No. EC120-88-003

SERVICE BULLETIN

Obsolescence of relay of the ELT antenna installation

The objective of this Service Bulletin is to replace the relay (reference R562743) because of obsolescence.

Figure 2

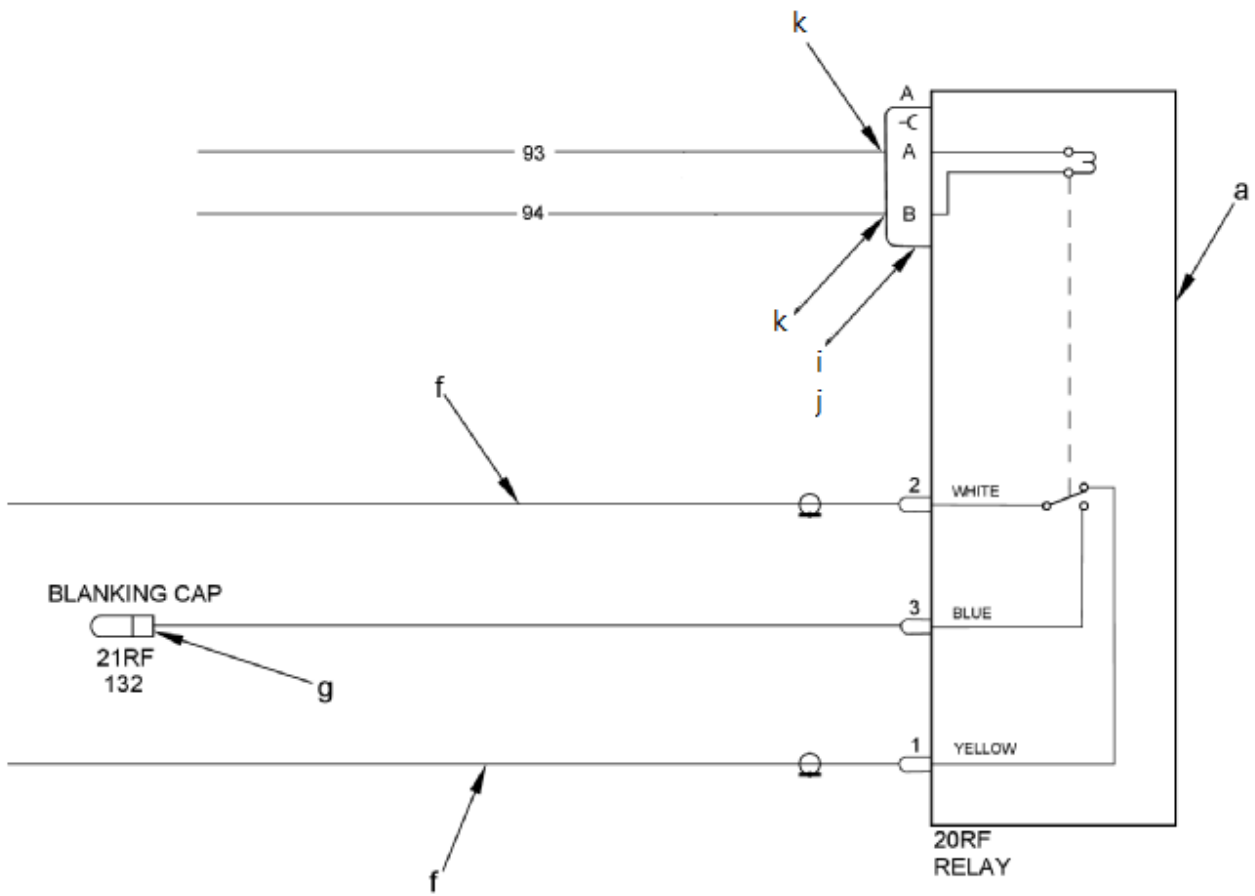
- Disconnect the connectors (f) from the relay (a) and put blanking caps (not shown) for protection ([Figure 2](#)).
- Remove and keep the blanking cap (g).
- Remove:
 - The union (i)
 - The connector (j)
 - The contact (k).
- Remove and discard the relay ([Figure 1](#) Detail B) with:
 - The bolts (c)
 - The washers (d)
 - The nuts (e)
 - The relay support (b).
- If in unsatisfactory condition, remove and discard the label "20RF" (h).

Figure 3

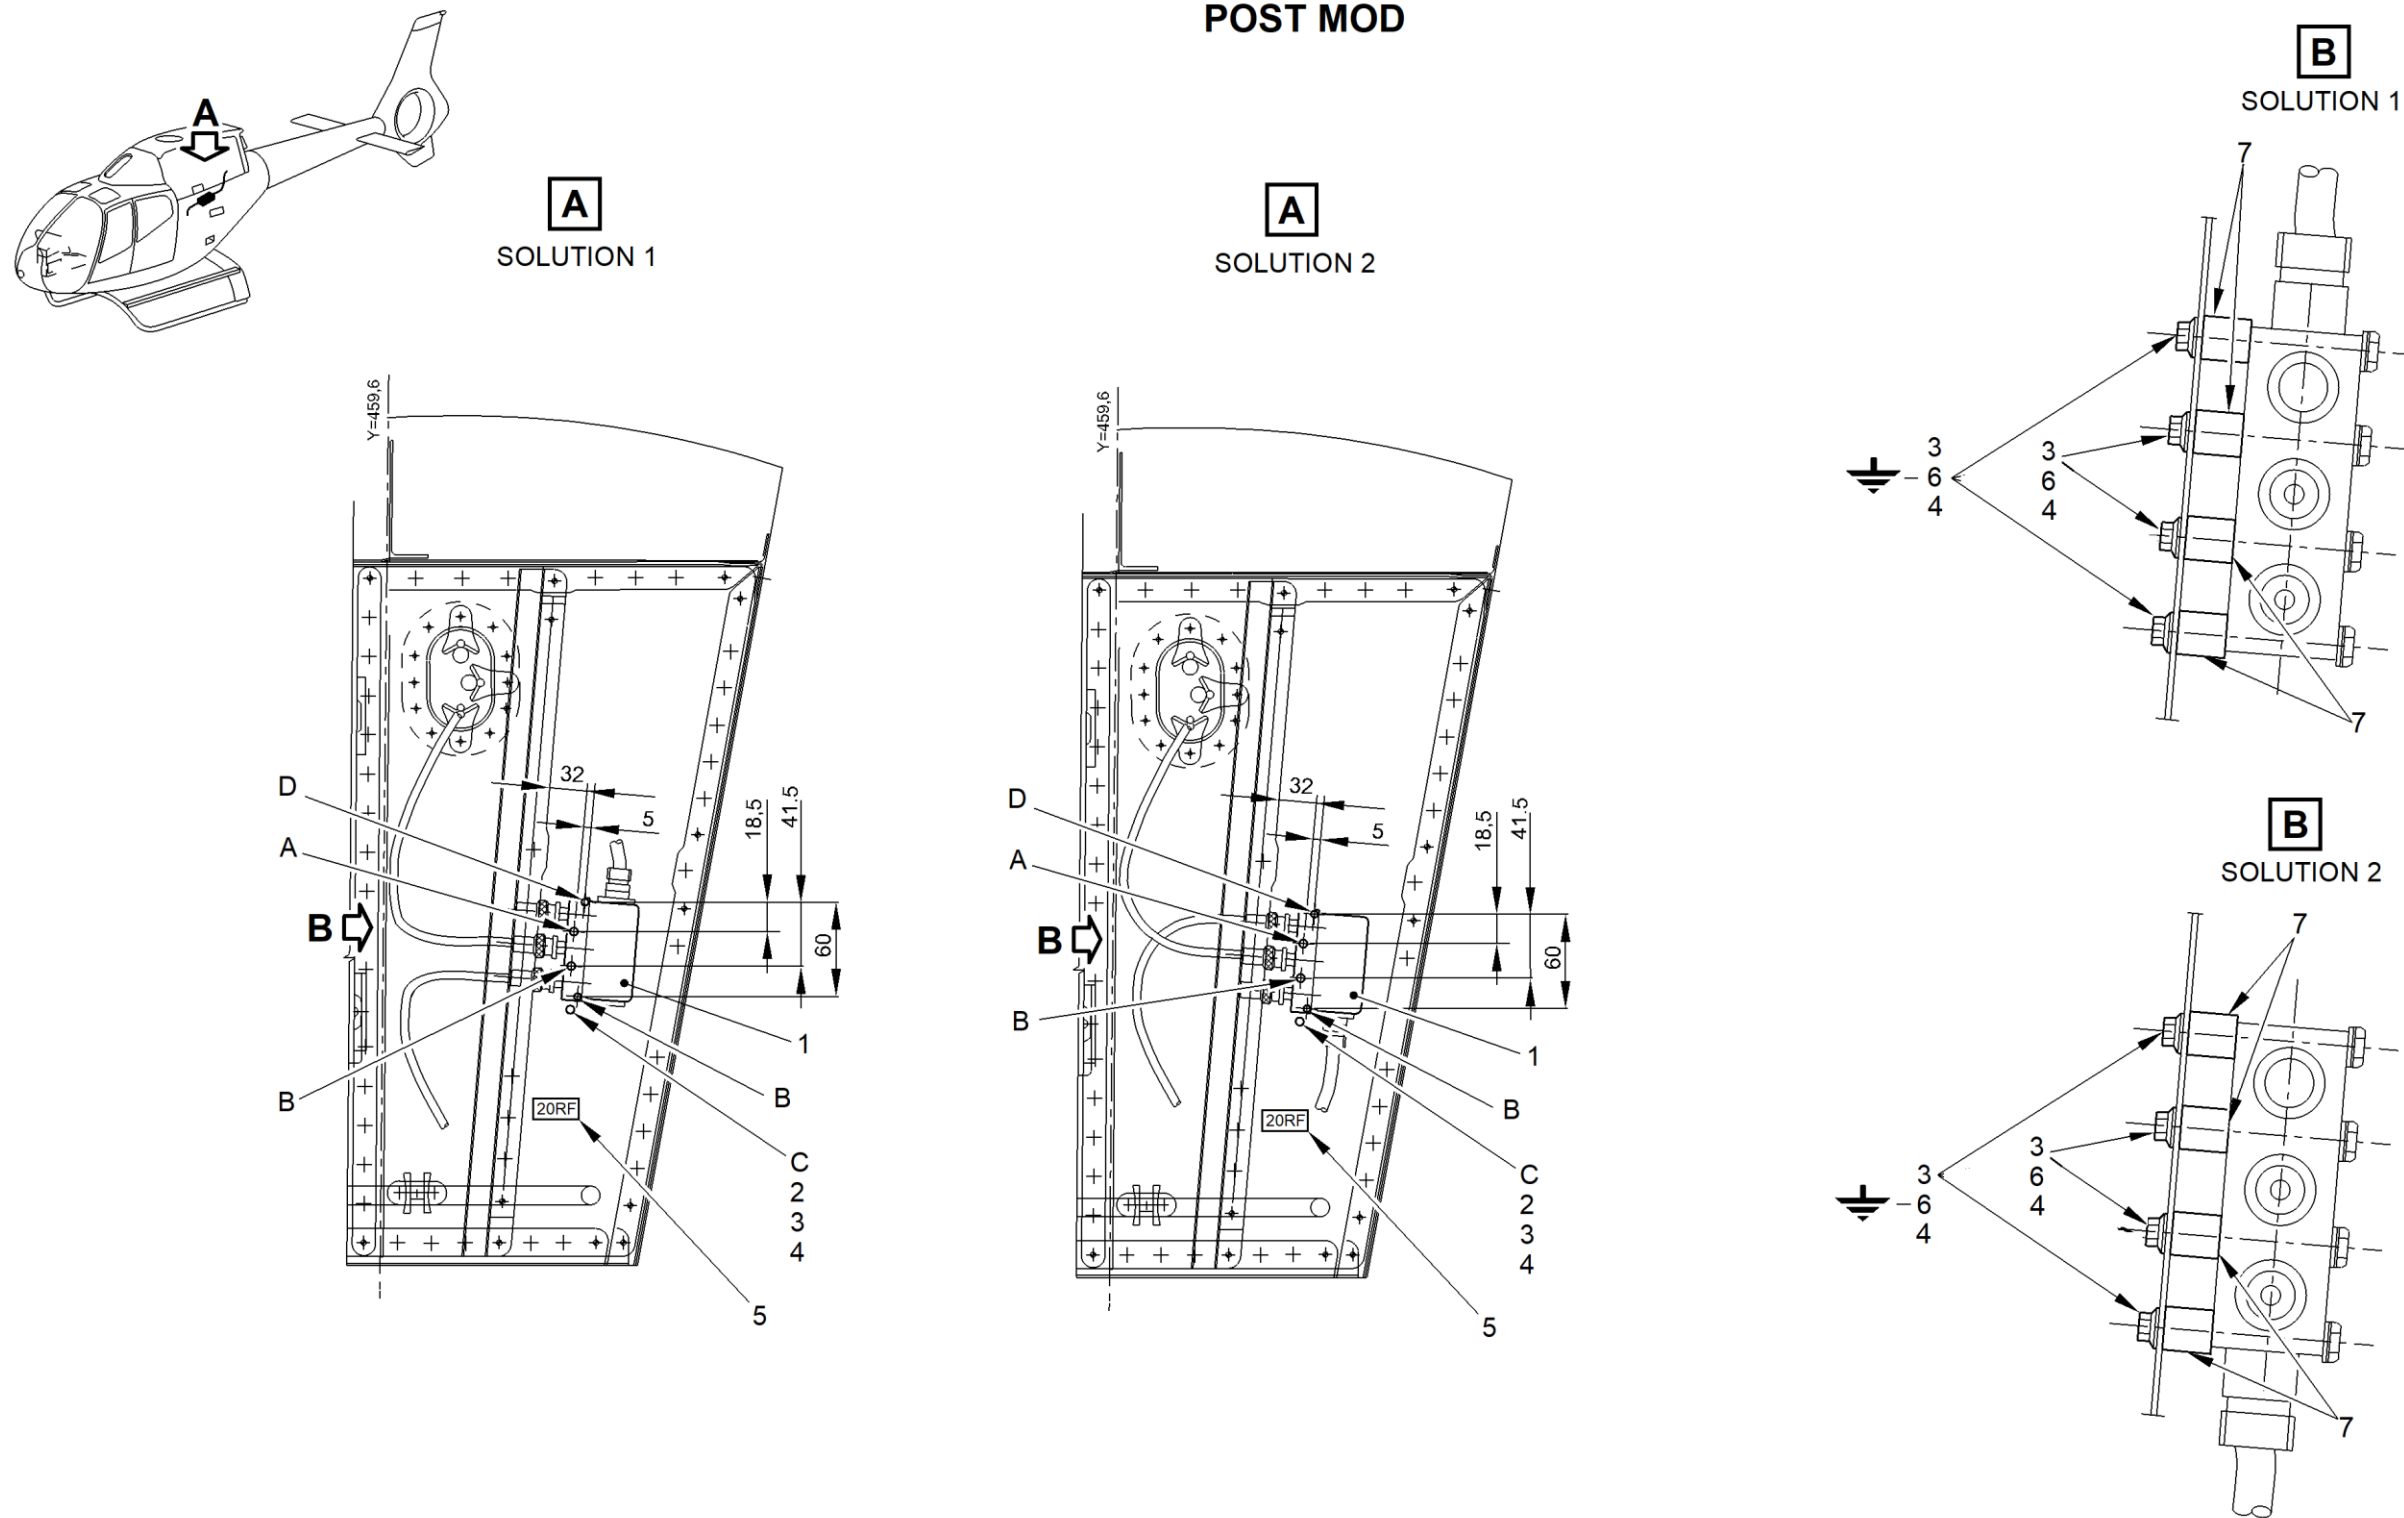
- If there is no hole (D) ([Figure 3](#) Detail A):
 - Identify the position of the hole (D) in relation to the hole (A). Refer to the dimensions.
 - Drill the hole (D) to 4.2 mm diameter.
- Identify the position of the holes (B) in relation to the hole (D). Refer to the dimensions.
- Drill the holes (B) to 4.2 mm diameter.
- Put the relay (1) in position to agree with the holes (A), (B) and (D).

Depending on the length of the wirings you can select between two positions of the relay (1) ([Figure 3](#), Solution 1 or Solution 2).

- Do the electrical bonding of the 2 screws (6) ([Figure 3](#) Detail B).
- Install the relay (1) with:
 - The screws (6)
 - The washers (3)
 - The spacers (7)
 - The nuts (4).
- Tighten the screws (6) to standard torque.
- Install in the hole (C):
 - The bolt (2)
 - The washer (3)
 - The nut (4).
- Tighten the bolt (2) to standard torque.
- Modify the electrical wiring with ([Figure 4](#)):
 - The union (8)
 - The connector (9)
 - The contacts (10).
- Do the continuity test of the changed wiring.
- Connect the connector (9) to the relay (1).
- Remove the blanking caps (not shown) from the connectors (f).
- Connect the connectors (f) to the relay (1).
- Install the blanking cap (g).
- If necessary, bond label "20RF" (5) as near as possible to the relay (1) ([Figure 3](#) Detail A).
